## Product Redesigned Bulletin

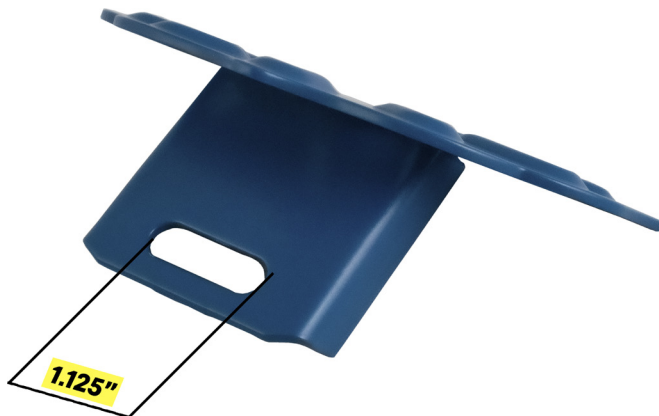
The Snow Defender<sup>®</sup> 85RF DECO™ has been redesigned, with a wider saddle, that allows easier installation with more S-5! Clamps<sup>®</sup>. The new saddle's opening is 2.125" I.D. (the old design had an opening of 1.625" I.D.). Additionally, the slot opening for attaching the 8mm bolt was lengthened from .625" I.D. to approximately 1.125". This allows greater flexibility for the bolt to align with the pre-drilled holes of the S-5! Clamps.

The new 85RF design will work with the following S-5! Clamps: S-5 N Grip, S-5 N 1.5, S-5 NH1.5, S-5 H-90, S-5 S, S-5 V, S-5 U, **\*S-5 Z\***, **\*S-5 T\***.
